AGENDA SECTION: PUBLIC HEARING	ORIGINATING DEPT: PLANNING	ITEM NO. E-7
ITEM DESCRIPTION: Final Plat #03-39 to be known as Foxfield Subdivision.		PREPARED BY: Mitzi A. Baker, Senior Planner

RE: Final Plat #03-39, by Foxfield LLC to be known as Foxfield subdivision. The Plat proposes to dedicate right-of-way for 50th Ave. NW, dedicate easements, and create one lot. The applicant is also requesting approval of a Substantial Land Alteration to permit the movement of more than 100,000 c.y. of earth material on the parcel. The property is located along the west side of 50th Ave. NW, north of the Douglas Trail and south of Middlebrooke Drive NW.

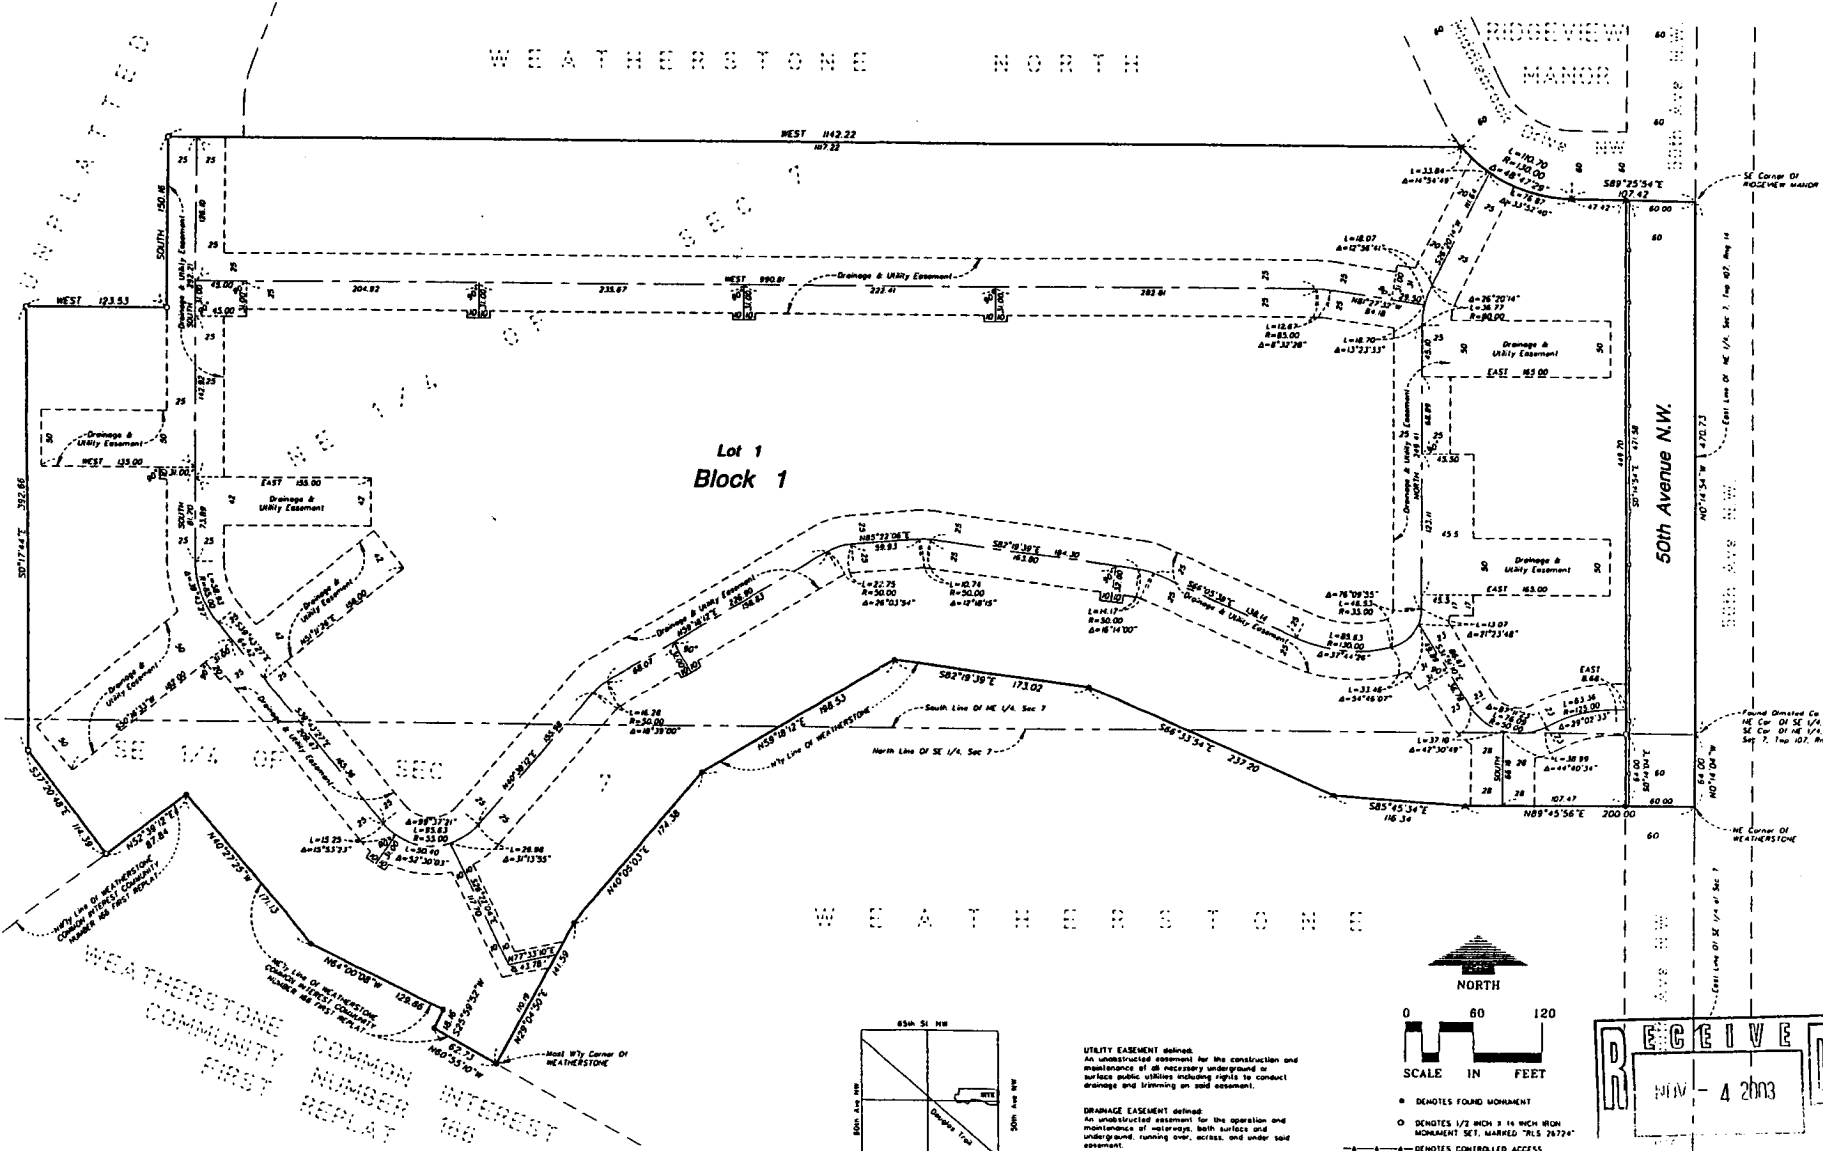
1. ***The Final Plat Documents shall include dedication of controlled access along the southerly frontage of Middlebrook Drive NW, from 50th Ave. NW, to the east line of the drainage & utility easement intersecting Middlebrook Dr. NW.***

SUBSTANTIAL LAND ALTERATION

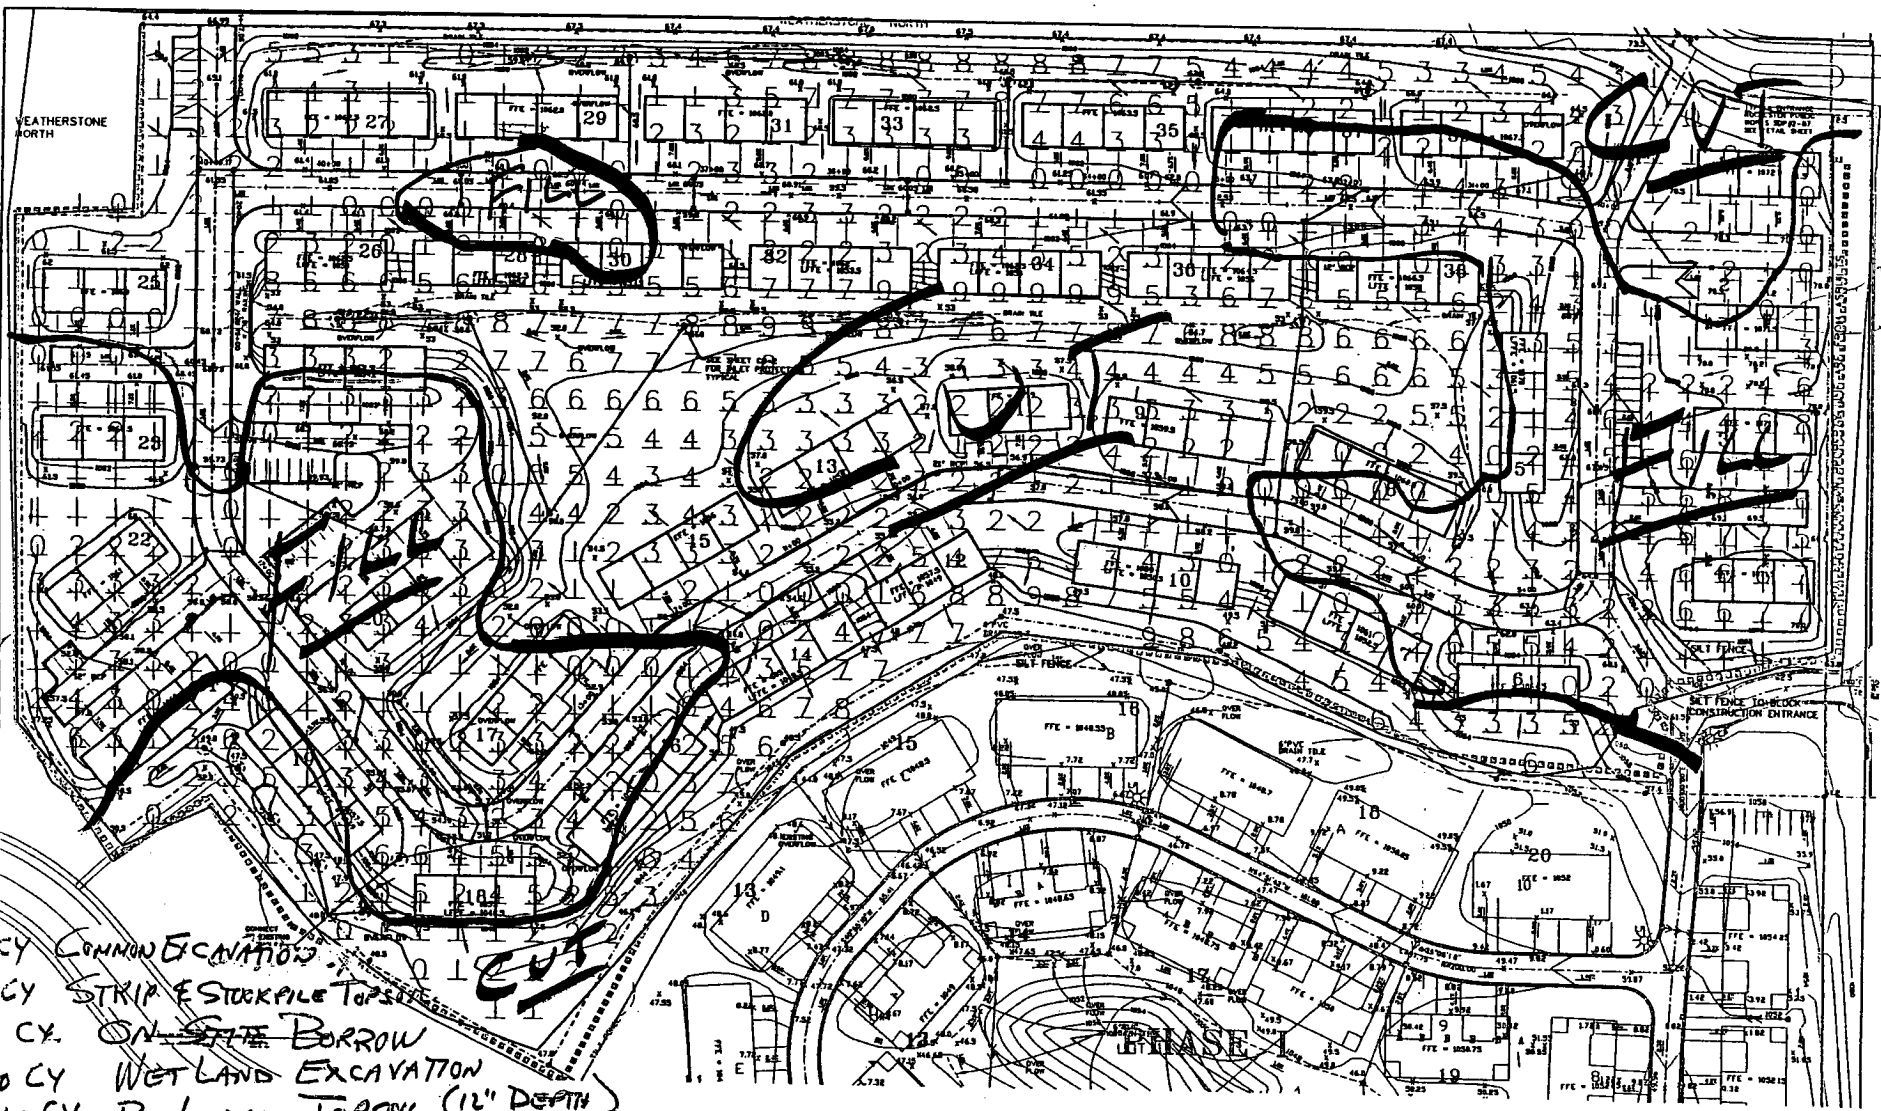
#13) The grading and drainage plans and erosion and sedimentation control plans must be approved by the City prior to commencement of grading activities on this property.

#14) The applicant must provide surety that guarantees that the site will be fully restored, after completion of the excavation activity, to a safe condition, and one that permits reuse of the site in a manner compatible with the Comprehensive plan, neighborhood plans, and Land use Plan and applicable City policies. Said surety must be provided prior to commencement of grading activities on this property.

- 1) *Not applicable.*
- 2) *Not applicable.*
- 3) *Not applicable.*
- 4) *The Rochester Public Works Department will need to review and approve the grading and drainage plan for this work. This plan must accommodate permanent and interim erosion and sediment control.*
- 5) *Not applicable.*
- 6) *Not applicable.*
- 7) *Not applicable.*
- 8) *Not applicable.*
